SUBMISSIONS REPORT#2: CROWS NEST OSD SITE B SSD-61400212

25 HUME STREET, CROWS NEST
LOT 3 DP 1296669

—
Prepared by Willowtree Planning Pty Ltd
for Third.i Crows Nest Residential Developments Pty Ltd

3 November 2025

Figure 1. Section View of a Typical Façade Planter (Source: Woods Bagot, 2025)

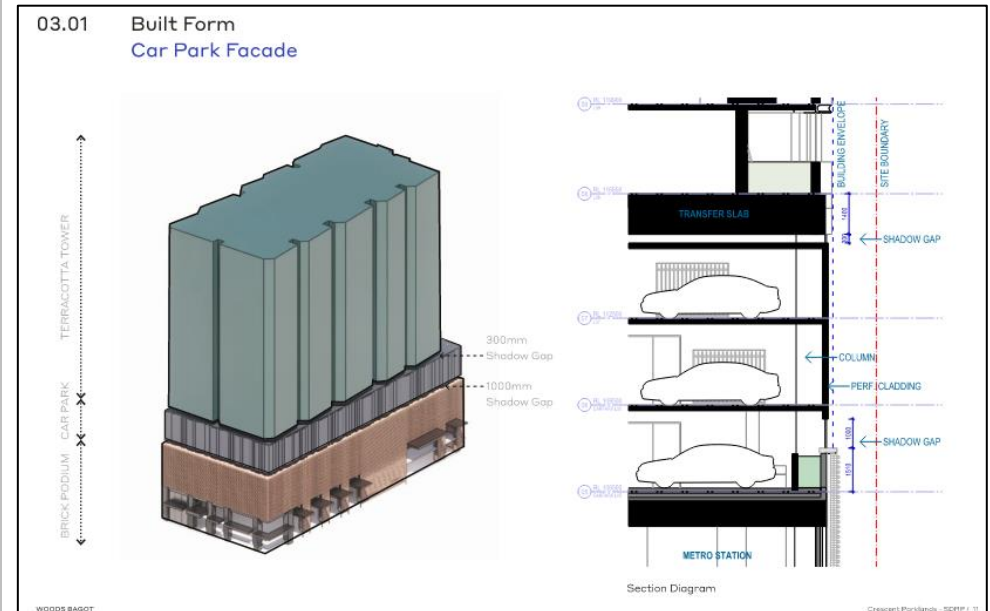
Matters Raised	Stakeholder	Response
Built Form		
<p>a) Review and revise the façade treatments of the car parking levels to provide an appropriate horizontal height datum/delineation between the station and the development (as recommended by the Design Guidelines) and to reduce its visual impacts. This may include consideration of:</p> <ul style="list-style-type: none"> i. Additional landscaping along the car parking level and provide details to demonstrate any landscaping would be practical and viable ii. Sections to indicate how the proposed new columns that are to be extended up to the transfer slab, and the car park façade screen are integrated. iii. The extent/ height of the terracotta façade and how that relates to the desired streetscape. 	<p>DPHI</p>	<p>A detailed response from the project architect (Woods Bagot) is provided at Appendix D1 which provides as follows:</p> <p>The façade expression at the car park level, above the metro station, is dictated by the location of structure that extends from the station. In some locations, this structure sits directly along the façade line, meaning that creating a recessive element at the car park levels poses a challenge. Regardless, we have designed the façade to read as a transitional and recessive element in the following ways:</p> <ul style="list-style-type: none"> • Landscaping has been provided around the extent of the car parking level except for where structure from the metro box prevents any landscape zone. • A lightweight, folded metal cladding in a dark finish is proposed to delineate between the green terracotta and red brick. This will be detailed with a shadow gap where it interfaces with the terracotta, and a landscaped edge where it interfaces with the metro station. • The folded metal will add depth to the façade as it picks up shadows across the day. The folded panels will also assist in integrating the structure that sit in line with the façade, notably along Clarke Lane and Hume Place, to create a unified horizontal expression between the OSD and the metro. • Shadow slot increased to 1m. <p>Drawings of this arrangement are shown at Appendix D1.</p> <p>Further to the above, the landscape consultant (RPS) has provided the below comments:</p> <p>Landscaping has been thoroughly interrogated across the extent of the podium through several building design iterations to ensure maximum possible landscape amenity is provided at the largest appropriate size; however as noted by the structural engineer in their response report, the ability for the built form to</p>

TABLE 3: RESPONSE TO ISSUES RAISED BY DPHI		
Matters Raised	Stakeholder	Response
		<p>accommodate landscaping around the podium skirt is restricted by structural column and slab requirements.</p> <p>With reference to the structural engineer's response report, landscaping can be maintained along three of the four facades with only planting to the Hume Street façade being omitted due to the introduction of a structural transfer slab removing planting opportunities.</p> <p>Façade planting to the balance of the podium skirt will have more than ample soil depth at approx. 1500mm deep with a 1000mm air gap above the soil FFL to allow for medium to large cascading stock to be installed; This allows for the maximum immediate vegetation screening possible. See Figure 1 below.</p>

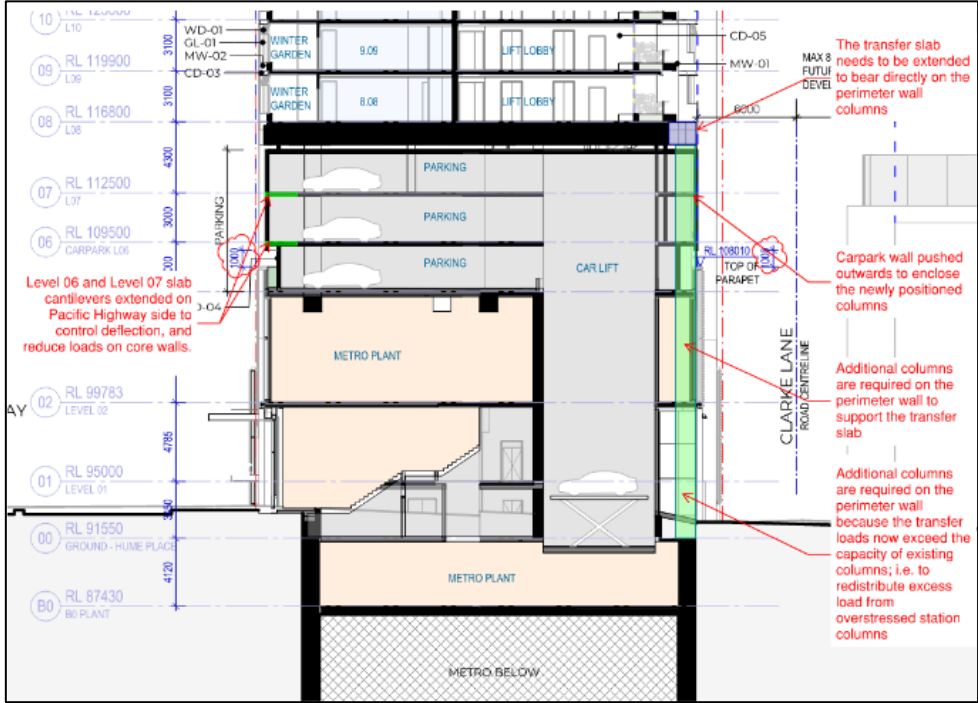
<p>c) Confirm whether the removal of the winter gardens on levels 9-15 for the selected dwellings will not compromise the amenity of those balconies in terms of wind conditions.</p>	DPHI	<p>Consideration of potential wind impacts associated with the removal of the winter gardens on Levels 9-15 has been undertaken by the wind consultant Arup (Appendix D2) who has provided as follows:</p>

TABLE 3: RESPONSE TO ISSUES RAISED BY DPHI		
Matters Raised	Stakeholder	Response
		<p>The proposed changes involve converting the middle wintergardens on the building's north face into balconies for Levels 9-13. Located centrally and away from high-wind corners, these spaces are open on one side and have an aspect ratio that limits recirculation. Overall, these modifications are expected to have minimal impact on local wind conditions for the affected balconies.</p>
<p>d) Similar to the evidence submitted in support of the proposed winter gardens, demonstrate how the dwellings can achieve adequate natural cross-ventilation where reliant on the internal corridors.</p>	<p>DPHI</p>	<p>Consideration of cross-ventilation has been undertaken by Stantec (Appendix D3) who have provided as follows:</p> <p>Natural ventilation strategies were incorporated in the most recent BASIX Certificate, presented in the ESD Report for Crows Nest OSD - Site B (revision 6). All units pass the minimum thermal comfort requirements (NatHERS heating and cooling loads) for BASIX, indeed the average NatHERS rating for the building is 7.9 Stars. The assessment confirms compliance with the minimum thermal comfort requirements (NatHERS heating and cooling loads) for BASIX and therefore achieves adequate natural cross-ventilation.</p> <p>A preliminary NatHERS assessment has been undertaken to evaluate the thermal performance of the updated dwellings. Low-level balustrades have replaced the fixed and high-level awning windows, thereby increasing open sections to further enhance natural cross-ventilation.</p> <p>Following this review, Stantec are of the opinion that the updated SSDA drawings will not compromise the dwellings' capability to achieve satisfactory natural cross-ventilation via internal corridors. Results from NatHERS modelling of the updated units indicates there will be no substantial change in heating and cooling loads. These models incorporate detailed thermal performance analysis for each apartment unit, accounting for window specifications, location, type, and the proportion of each window that may remain safely open to support natural ventilation. Balconies are also considered in the models to reflect their impact on both natural ventilation and shading, which are essential factors in the overall thermal efficiency of each unit. In summary, the dwellings offer adequate natural cross-ventilation through balcony windows and are not dependent solely on internal corridors.</p>

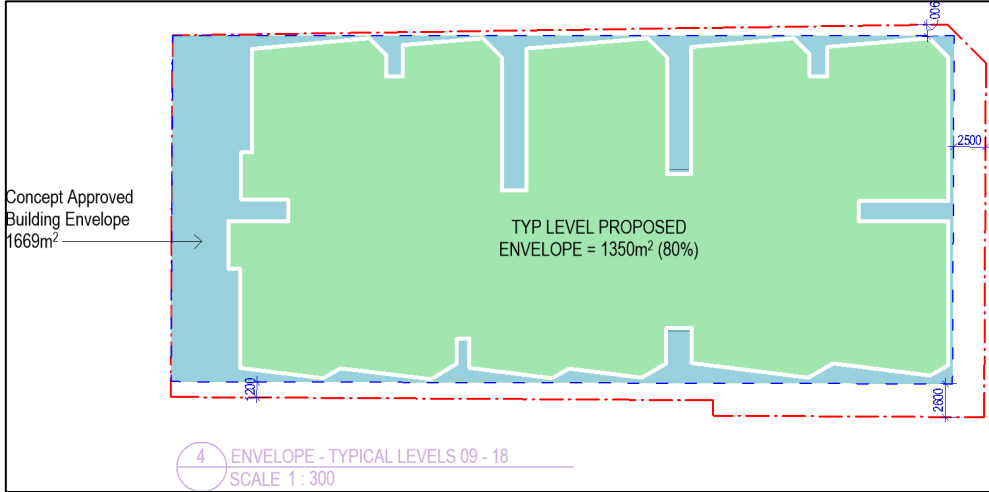
b) Confirm compliance with Condition B3 of the Concept Approval and provide supporting illustrations showing how the proposal satisfies the building efficiency target of 80%.	DPHI	A response from the project Architect is provided at Appendix D1 which includes the below diagram that illustrates compliance with the 80% building efficiency target as shown in Figure 2 below:

TABLE 3: RESPONSE TO ISSUES RAISED BY DPHI		
Matters Raised	Stakeholder	Response
		 <p>Figure 3. 80% Building Efficiency Target (Source: Woods Bagot, 2025)</p>
Amenity		
<p>Provide further details, including supporting documentation and drawings to illustrate how the proposal will meet the objectives and criteria of the Apartment Design Guide (ADG). This must include:</p> <p>a) How the proposal maximises solar access, including identifying:</p> <ol style="list-style-type: none"> i. the number of apartments that receive two or more hours of solar access ii. the extent of solar access received by those apartments that receive less than two hours of solar access; and iii. the extent of apartments that receive no direct solar access. 	<p>DPHI</p>	<p>A detailed response from the project Architect (Woods Bagot) is provided at Appendix D1 which provides as follows:</p> <p>Drawings DA-2303, DA-7721, DA07722 address solar access to units. 62% (76 units) achieve more than 2 hours of direct sunlight between 9am and 3pm at mid-winter. 38% (46 units) achieve 1 hour 45 minutes of solar access between 3:15 -5pm at mid-winter. Achieving the ADG design guidance for solar access is not possible on this site due to the long east and west orientation. The proposed development improves amenity for those apartments with less direct sun access in the following ways:</p> <ul style="list-style-type: none"> • Significant views are oriented away from the desired aspect for direct sunlight along the western Pacific Highway façade. The proposal orients the west facing units to the south where there are views back to the harbor and city.
